A47 North Tuddenham to Easton Dualling

9.29 Applicant's Written Summary of Oral Submissions at ISH3

**APPLICANT'S WRITTEN SUMMARY OF ORAL SUBMISSIONS
AT ISH3**

Regulation Number:	Rule 8(1)(c)
Planning Inspectorate Scheme Reference	TR010038
Application Document Reference	TR010038/EXAM/9.29
Author:	A47 North Tuddenham to Easton Project Team, Highways England

SECTION E - 'E' OVERVIEW
SCALE 1 : NTS

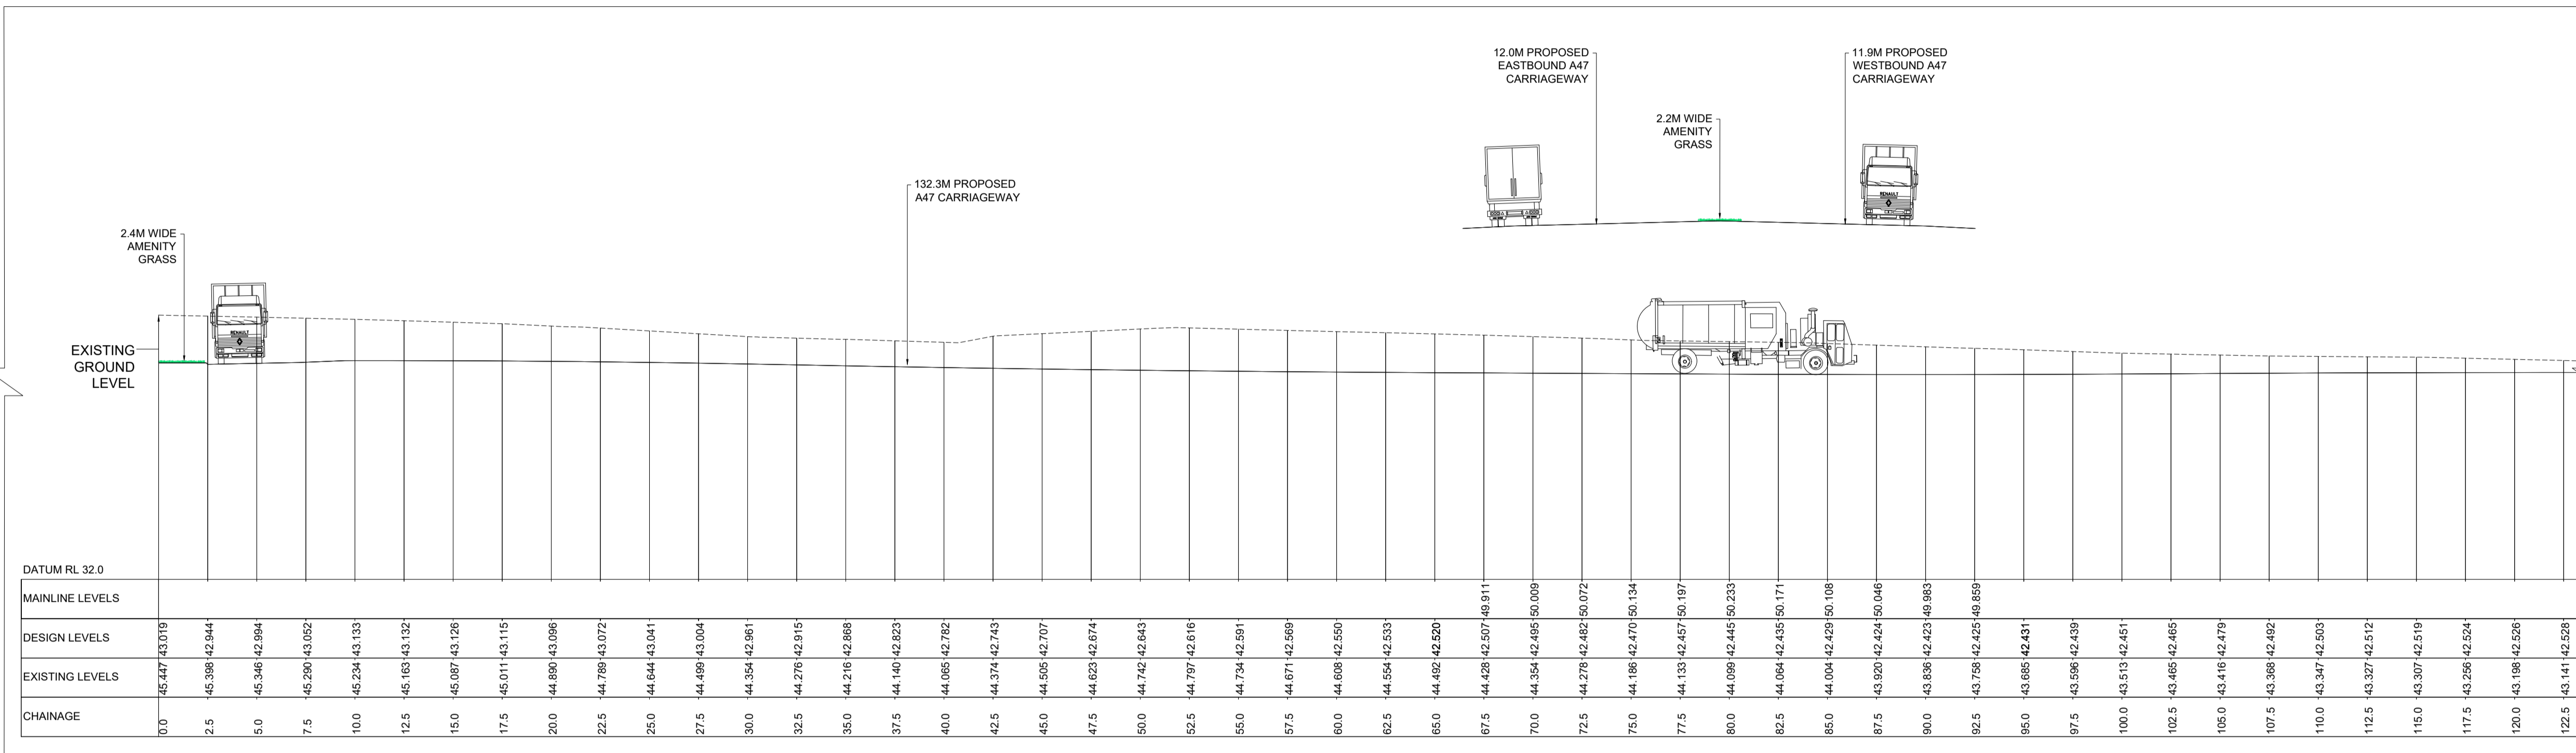
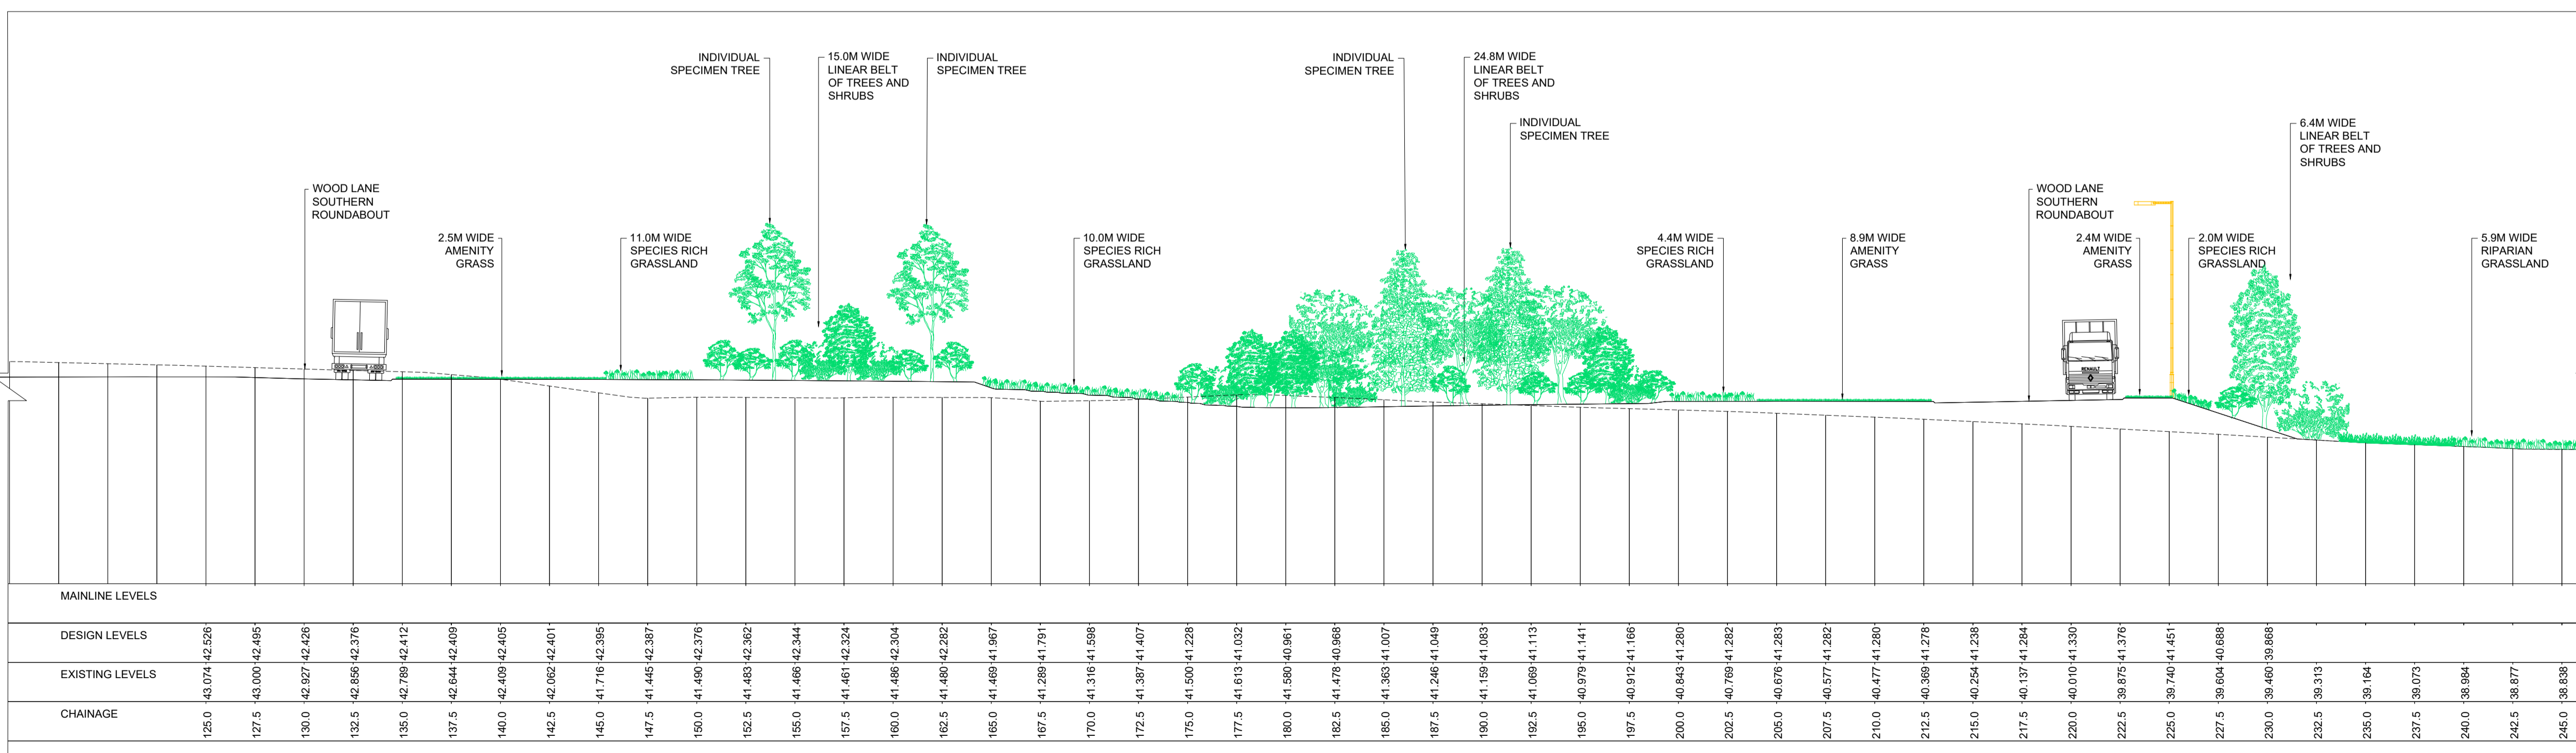
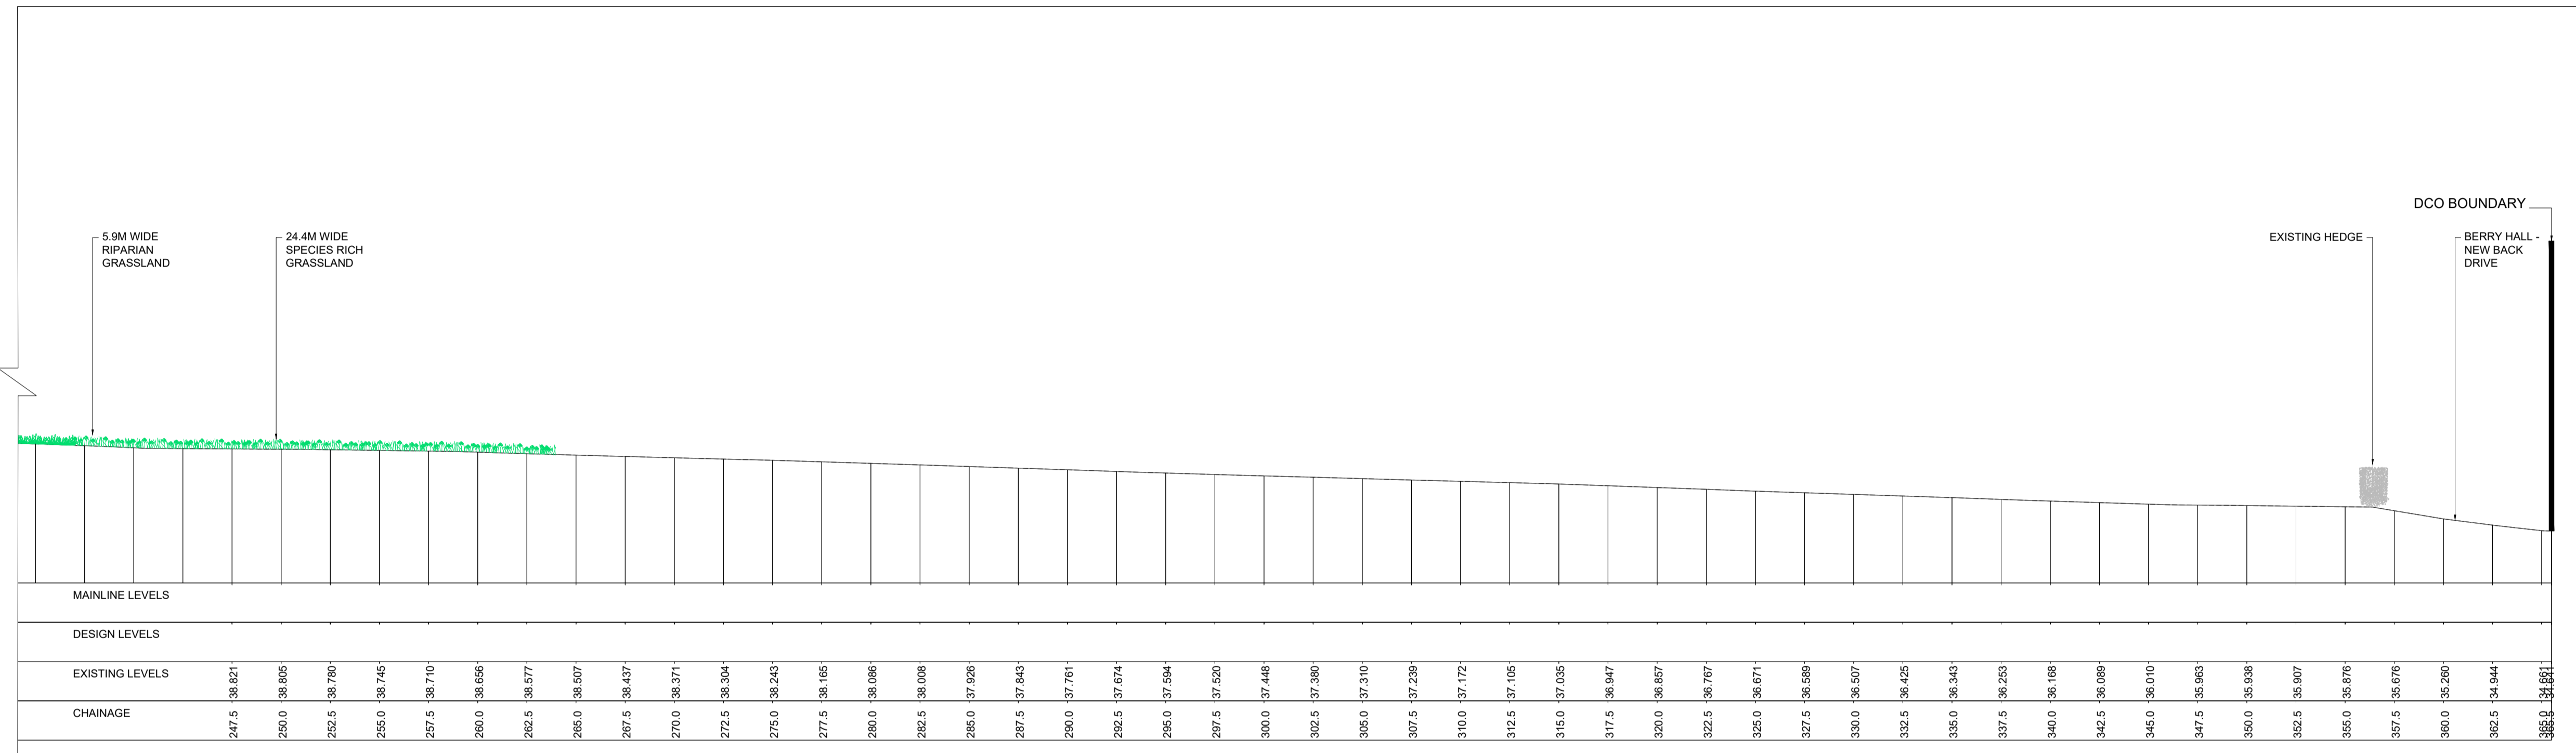
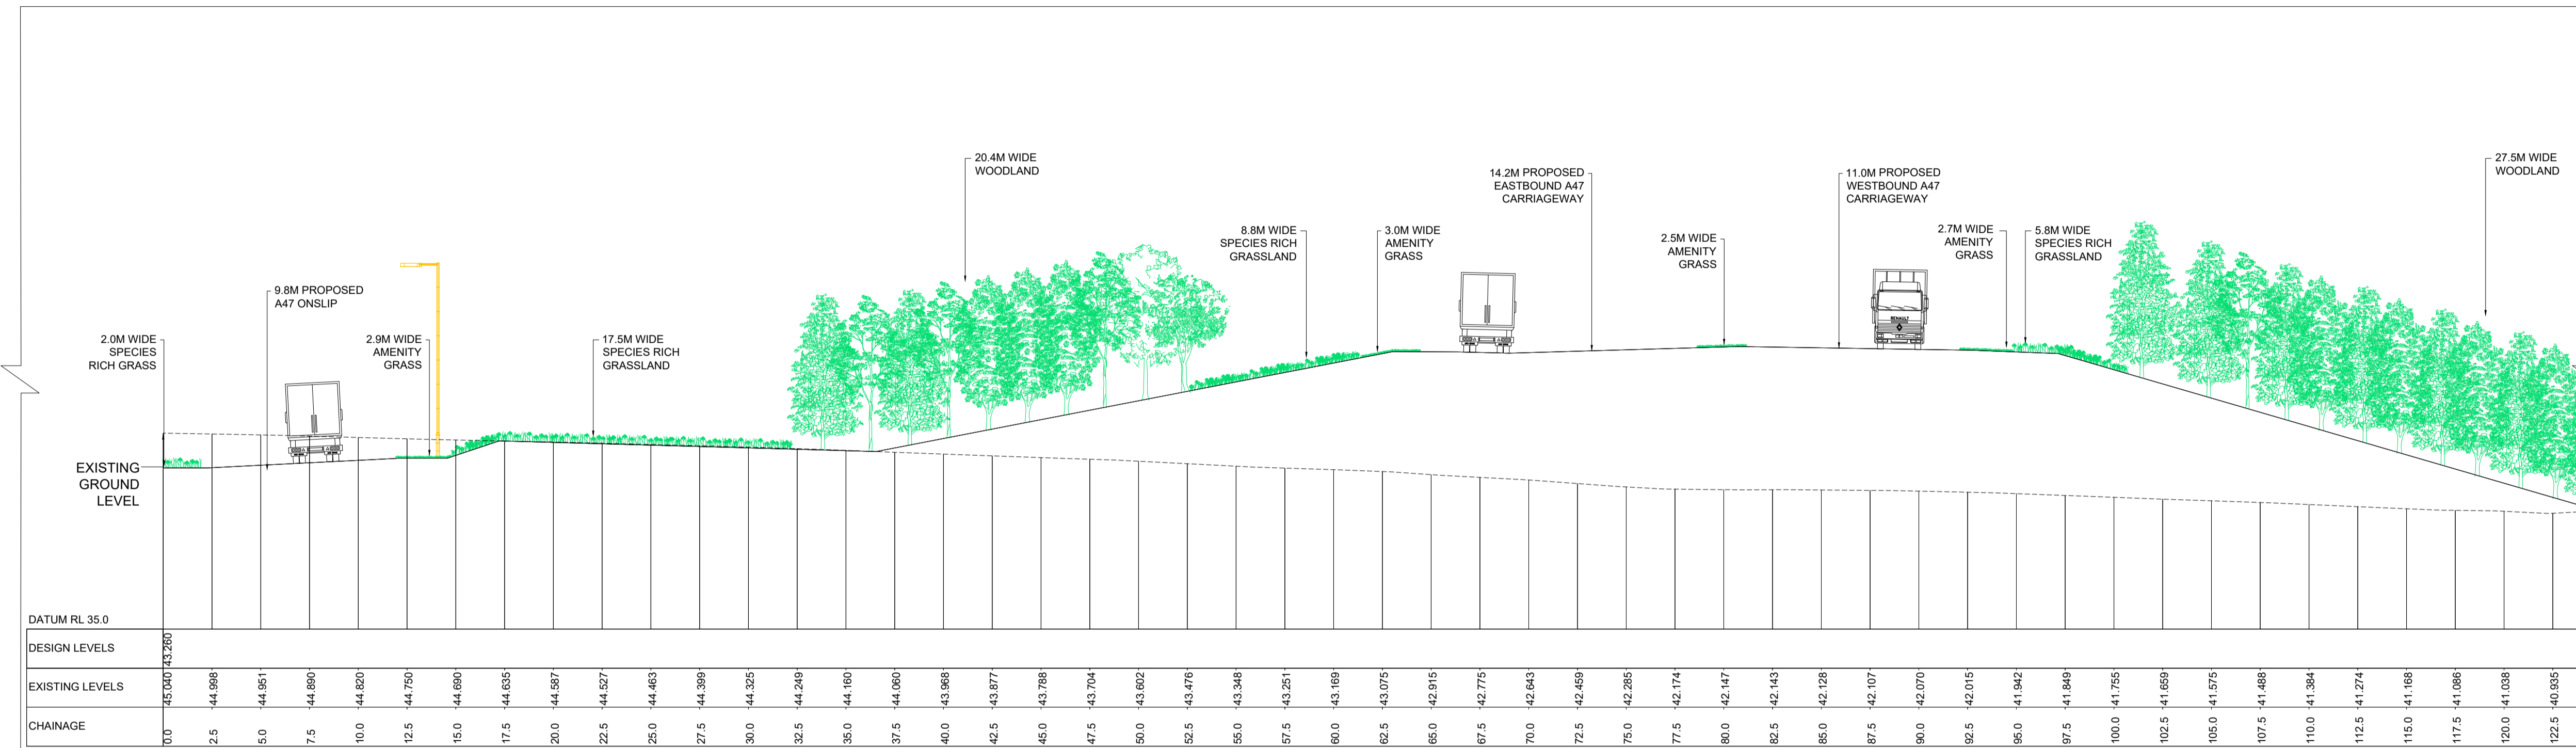
41.	<p>The ExA highlighted a question raised in a previous ISH in relation to the methodology used for cross-sectional drawings.</p> <p>The ExA also queried whether any lighting columns are shown on the cross-sections.</p> <p>George Josselyn asked if it would be possible to delineate the existing trees with those proposed by a change in the colouring and if a line could be drawn showing the limit of the permanent acquisition of land on the cross-section.</p>	<p>The Applicant stated that it would respond in writing to this question with a brief methodology on the preparation of the cross-sections Mr Josselyn referred to.</p> <p>The cross-sections were produced in line with the latest information and data, including topographic data, arboricultural data and the arboricultural masterplan (REP3-016) and are intended to show the scheme planting at a reasonable level of maturity. The existing (retained) trees are shown using data from the arboricultural assessment which makes the retained trees as accurate as possible on the sections.</p> <p>In relation to the lighting columns the Applicant stated that there are no lighting columns that directly dissect the section lines but that the Applicant will include indicative columns within areas to be lit to indicatively illustrate their relative scale and location.</p> <p>In relation to the cross-section drawings the Applicant highlighted that the limit of permanent acquisition is shown by reference to the Highway Boundary Fence. Existing vegetation has also already been annotated on the plans.</p>	<p>Appendix A of this ISH3 hearing note contains updates to the cross-section drawings submitted as Appendix A to the 'Applicant's Response to the Examining Authority's Third Written Questions' (REP6-018). The approach to producing the cross-sections was as follows:</p> <ul style="list-style-type: none"> • The location of the sections was selected to give a range of illustrative material within the vicinity of the proposed junctions and based on a request from the landowners agent for sections at chainages through the road centreline and southwards into Berry Hall Estate. The Applicant reviewed the chainages and provided sections as required including an additional section (Section F-F) not requested by the landowner. • The sections were produced using the Scheme design submitted for Examination, existing topographical survey data and exported from the 3D modelling software.

Ref	Questions / Issues Raised at ISH3 and Hearing Action Points	Summary of Applicant's Response at ISH3	Applicant's Written Response
		<p>The applicant will update the visual representation of existing/proposed vegetation and the freehold boundary in a re-issue of the sections.</p>	<ul style="list-style-type: none"> • The retained existing tree cover is illustrated as accurately as possible, utilising project arboricultural information (refer to APP-094, Appendix 7.6). The height of retained existing trees is represented utilising surveyed heights from the arboricultural report, but does not account for future growth post that survey. • As part of the Scheme, the following key components are also shown: <ul style="list-style-type: none"> - Proposed mitigation planting. Planting information is taken from the Environmental Masterplan (AS-007) and is shown at 8m above proposed ground level, therefore linking to Table 7-6 of EIA Chapter 7 (APP-046) which defines planting heights at Year 15 of operation of the Scheme. - The proposed highway boundary is shown by inclusion of the "Highway Boundary Fence". - Indicative locations of lighting columns are shown at 10m in height, as assessed in the EIA. - Vehicles on the Scheme are shown at a maximum of 4m in height (above road level), the tallest vehicles being lorries.
